Geologic and Soils Engineering Plan Review and Update Report

November 19, 2019
IC 14073-I

Geologic and Soils Engineering Plan Review and Update Report
Proposed 9 Lot Subdivision
Vesting Tentative Tract No. 65348
1935 Stonehouse Road/935 E Grandview Avenue
Sierra Madre, California

Enc: Geologic Map and Sections A through C

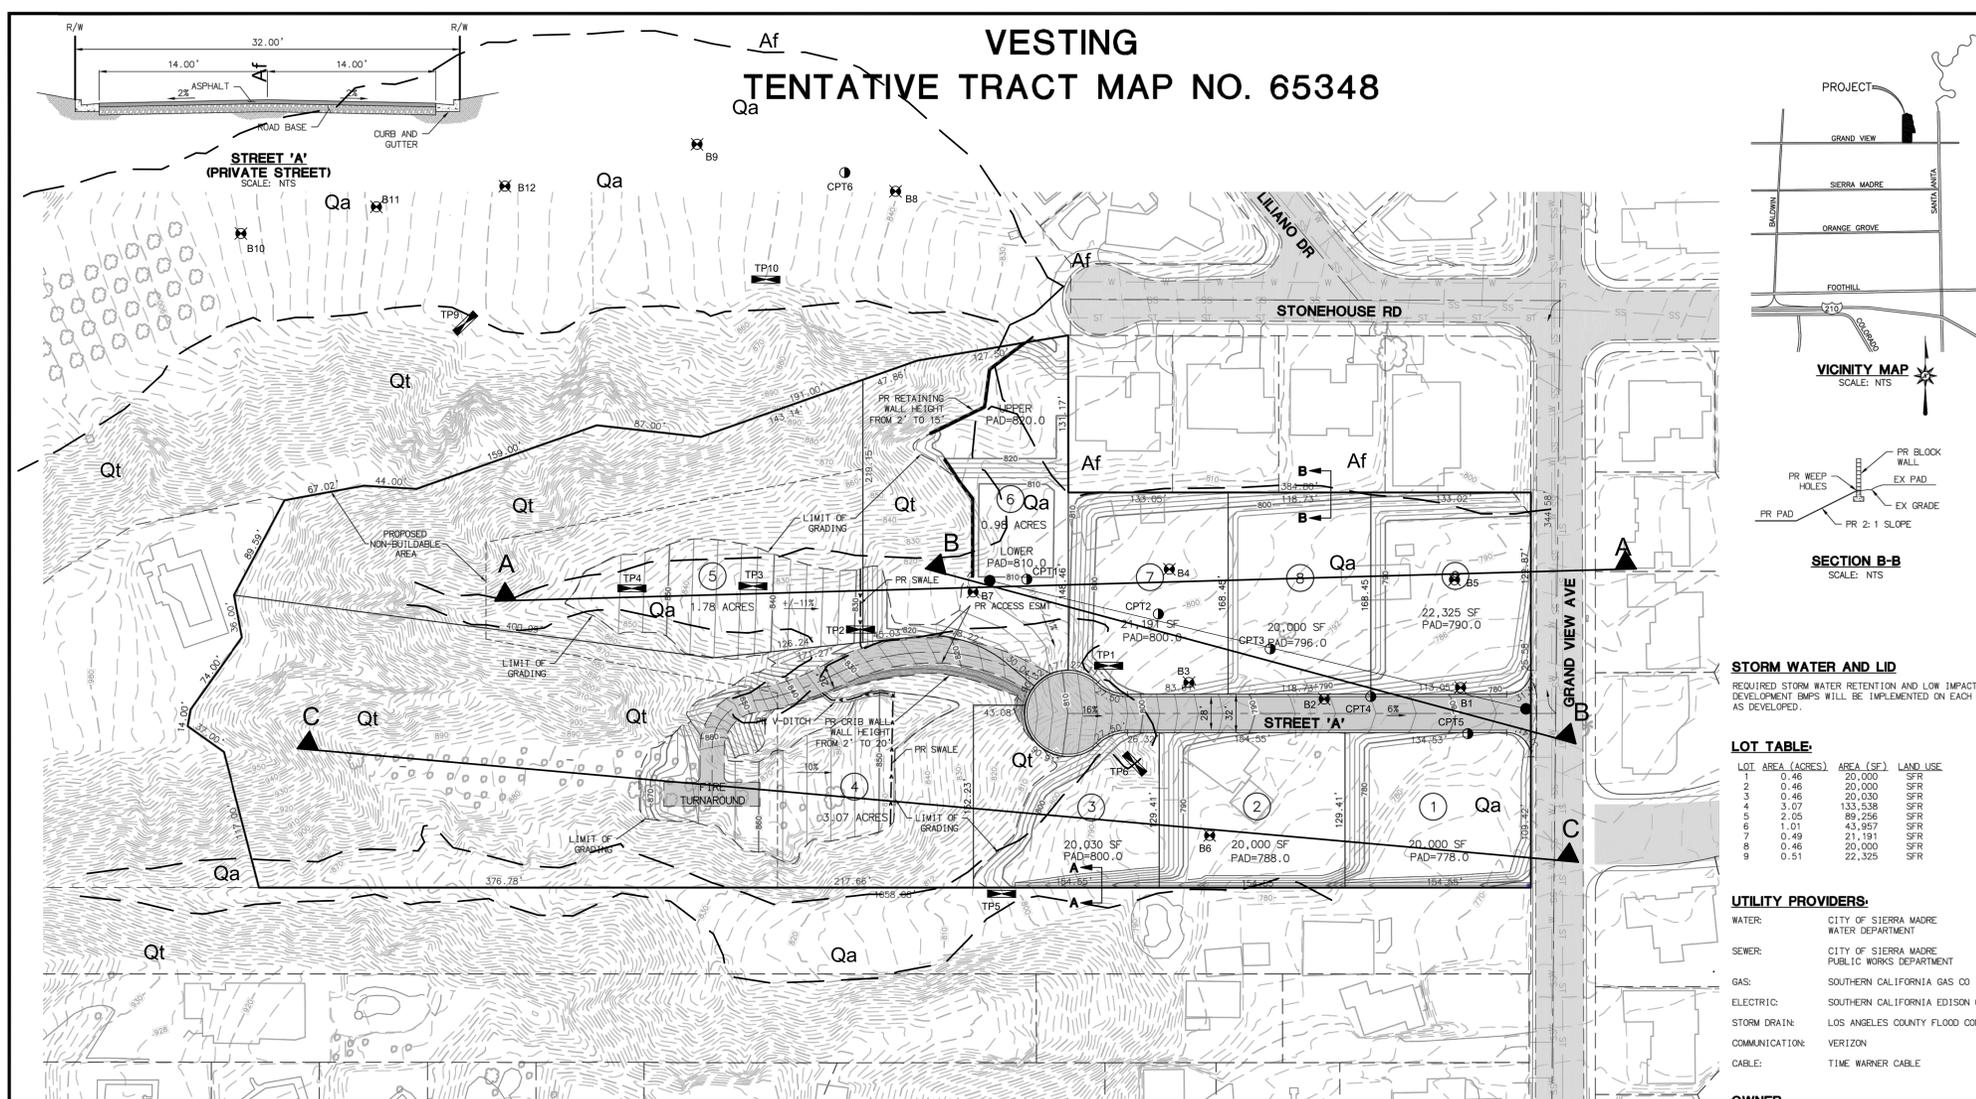
The project scope has been reduced from what was previously studied and presented in the referenced reports. It is proposed to subdivide the property to create 9 lots. A building pad suitable for development with a single-family residence will be created on each lot. All of the lots will be accessed from Grand View Avenue via a new street (Street "A"). Two to 15-foot retaining walls are proposed along the uphill sides of the split level pads on Lot 6. Debris basins are not planned for this project. The proposed project is shown on the updated Geologic Map and Sections A through C.

The proposed lots and building pads are remote to significant slopes and the proposed grading and development will not reduce site stability. The findings of the previous reports that the bedrock and native alluvial deposits are stable and capable of supporting engineered grading and structures remain valid and applicable. The proposed graded slopes will be less than 10 feet high and 2:1 in gradient. The proposed building sites are not subject to geologic hazards posed from surface fault rupture, liquefaction, lateral spreading, seismic ground failure, landsliding, settlement, lurching, mudflows, or expansive soils.

The recommended bearing material for all the residential structures on the proposed pads is compacted fill. The pads and building sites should be prepared and graded in conformance with the SITE PREPARATION section of the previous report. Recommendations for design of foundations, slabs, pavements, retaining walls, and drainage control remain valid and applicable.
